LPTIP - A61(S)
IMPROVEMENT WORKS
GENERAL ARRANGEMENT
SHEET 1 OF 5

Design change 27/02/19

- Design change 27/02/19 – Option 1
- Relocate the outbound bus stop towards Crown Point Road
 - Enables the proposed development plot which will not be practical with the bus stop location as currently proposed
 - Better for serving Crown Point Retail Park and better bus stop spacing than Option 2
 - Worse in so far as it is kerbside, but this is mitigated by being so close to the exit from the junction

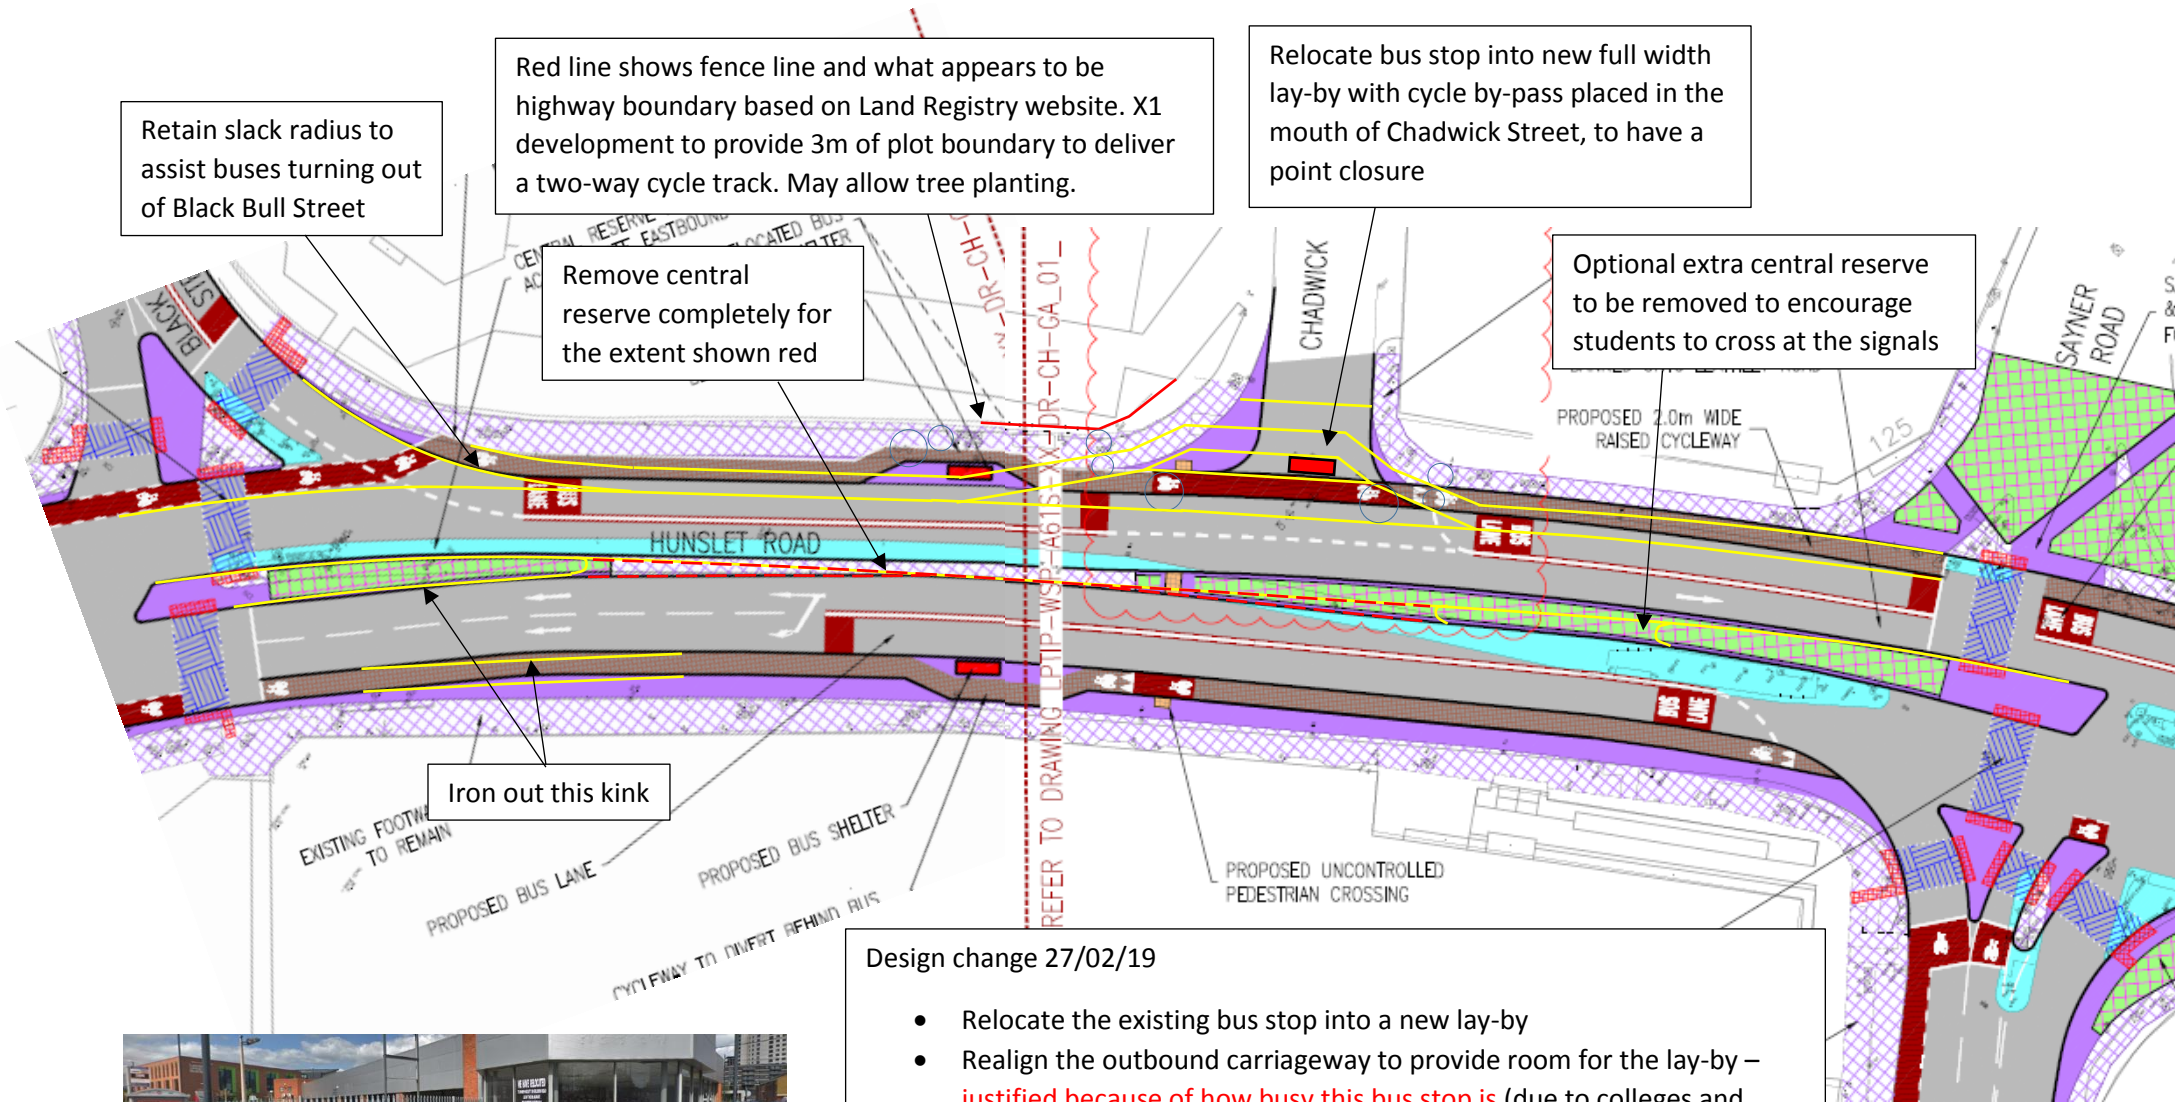
Retain slack radius to assist buses turning out of Black Bull Street

Red line shows fence line and what appears to be highway boundary based on Land Registry website. X1 development to provide 3m of plot boundary to deliver a two-way cycle track. May allow tree planting.

Relocate bus stop into new full width lay-by with cycle by-pass placed in the mouth of Chadwick Street, to have a point closure

Optional extra central reserve to be removed to encourage students to cross at the signals

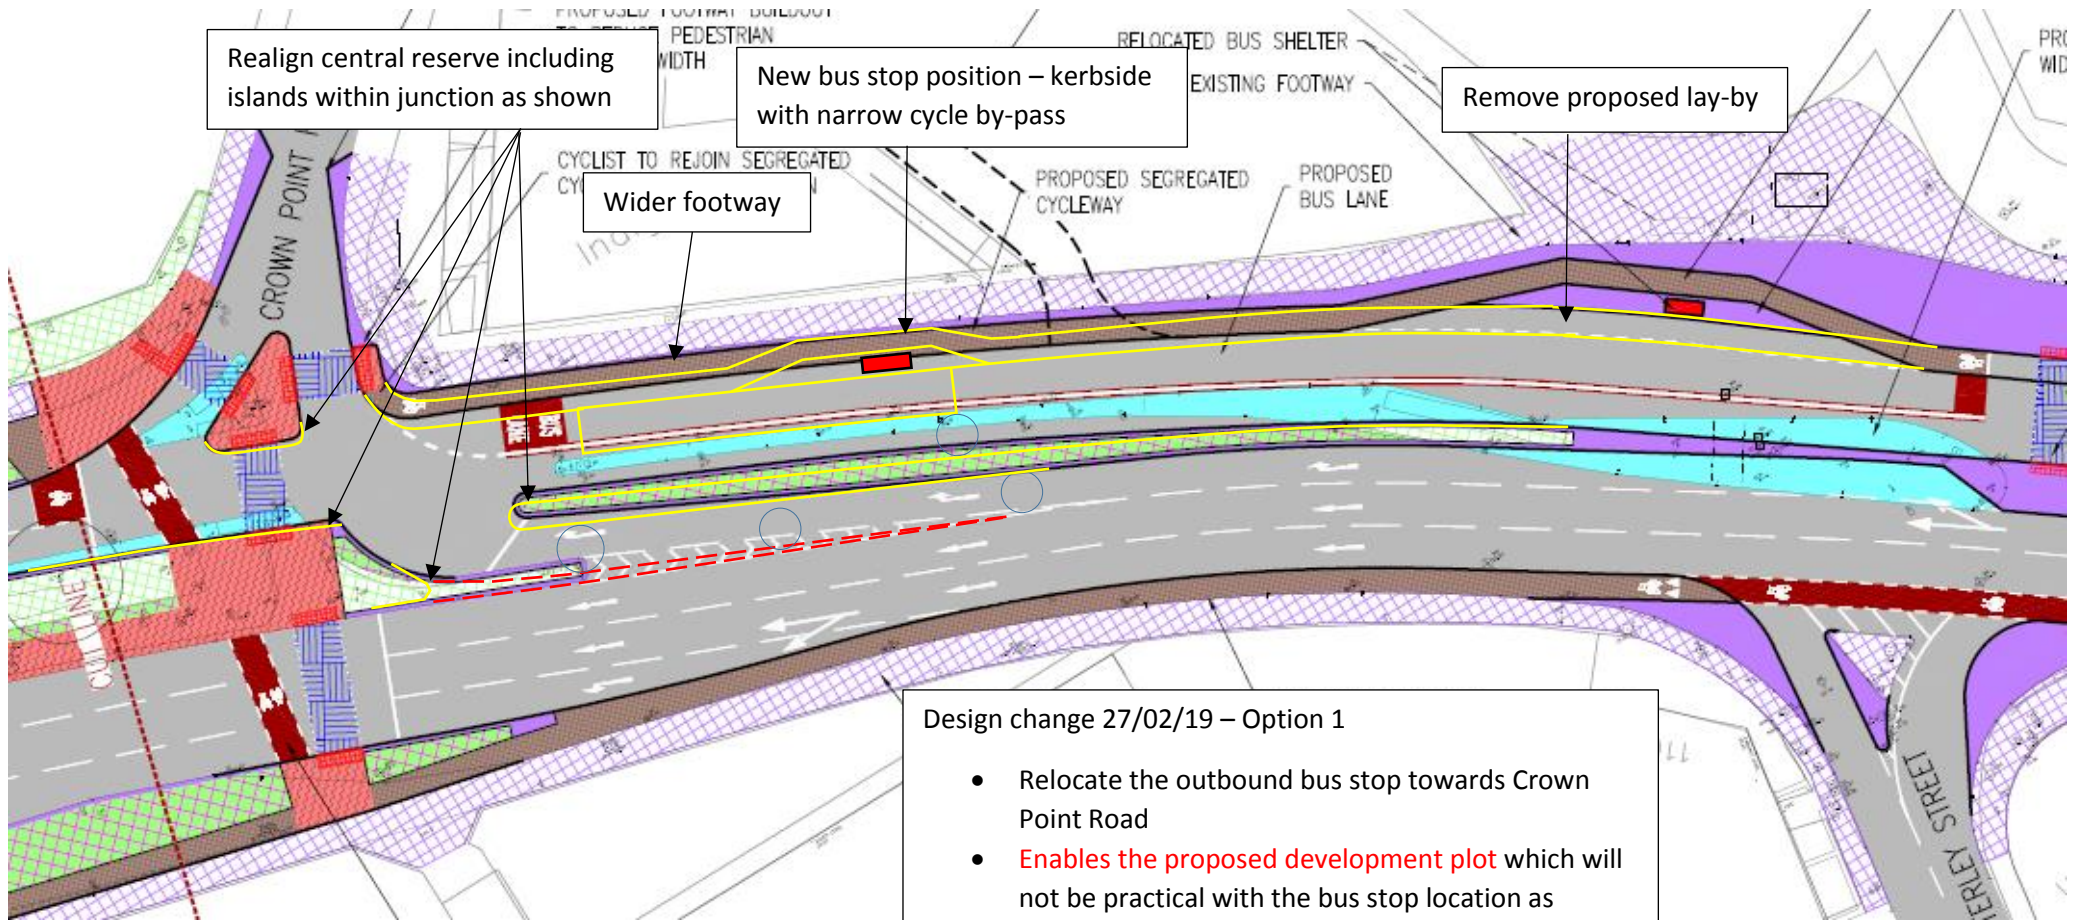
Remove central reserve completely for the extent shown red

Iron out this kink

- Relocate the existing bus stop into a new lay-by
- Realign the outbound carriageway to provide room for the lay-by – **justified because of how busy this bus stop is** (due to colleges and surrounding businesses) and potential delays to P&R buses
- Remove the central reserve to provide space for the bus stop; similar to A61 cross-section southeast of the ring road.
- It also is important because of the proposed relocation of the previous stop (see next page)

Realign central reserve including islands within junction as shown

New bus stop position – kerbside with narrow cycle by-pass

Remove proposed lay-by

Wider footway
